Figure 3.4.6.1-1
Hydrostatic Pressure and Leak Tests Pressure/Temperature Limits - Curve A

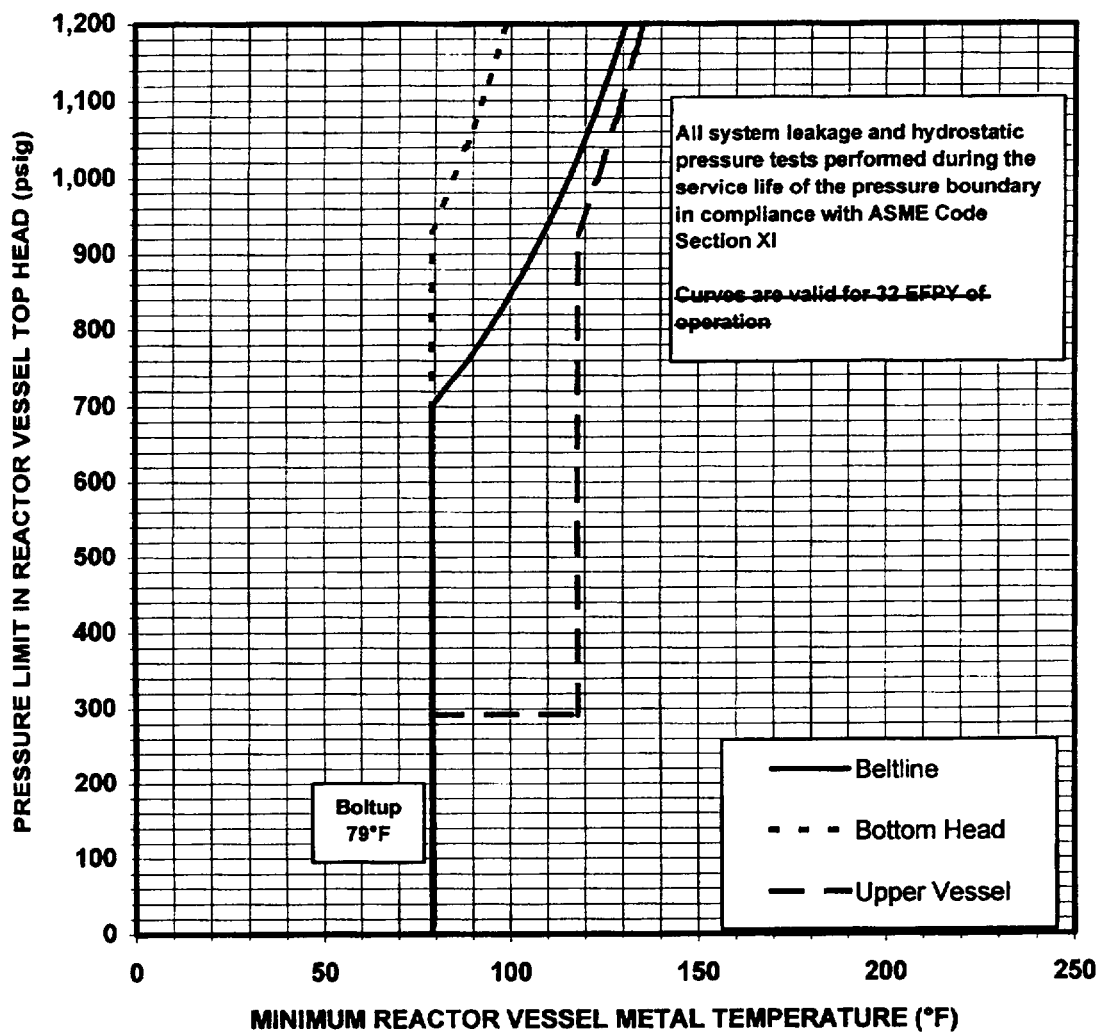
Note: This figure is valid through Cycle 44 12 Operation in accordance with NRC Safety Evaluation Report supporting Amendment No. 139

Figure 3.4.6.1-2
Non-Nuclear Heatup and Cooldown Pressure/Temperature Limits - Curve B

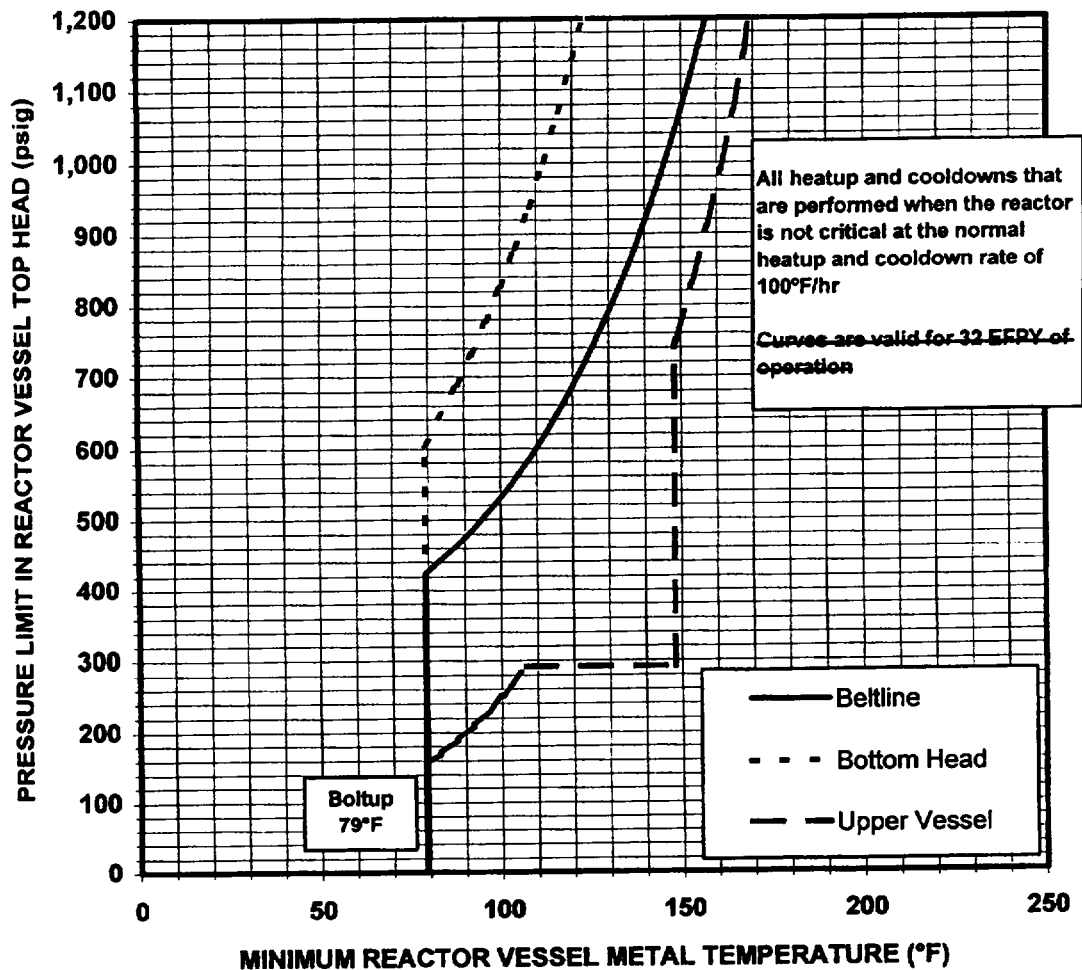
Note: This figure is valid through Cycle 44 12 Operation with NRC Safety Evaluation Report supporting Amendment No. 139

Figure 3.4.6.1-3
Core Critical Heatup and Cooldown Pressure/Temperature Limits - Curve C

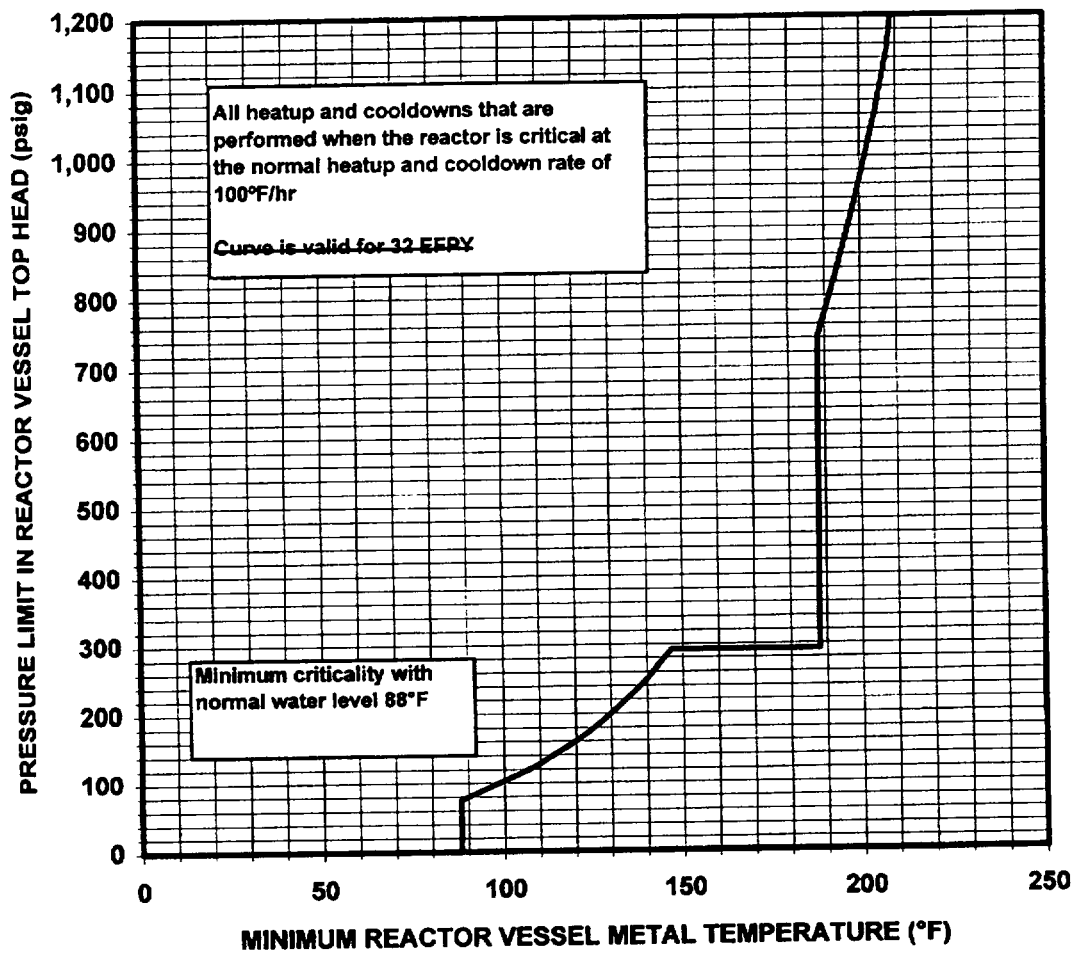
Note: This figure is valid through Cycle 44 12 Operation in accordance with NRC Safety Evaluation Report supporting Amendment No. 139
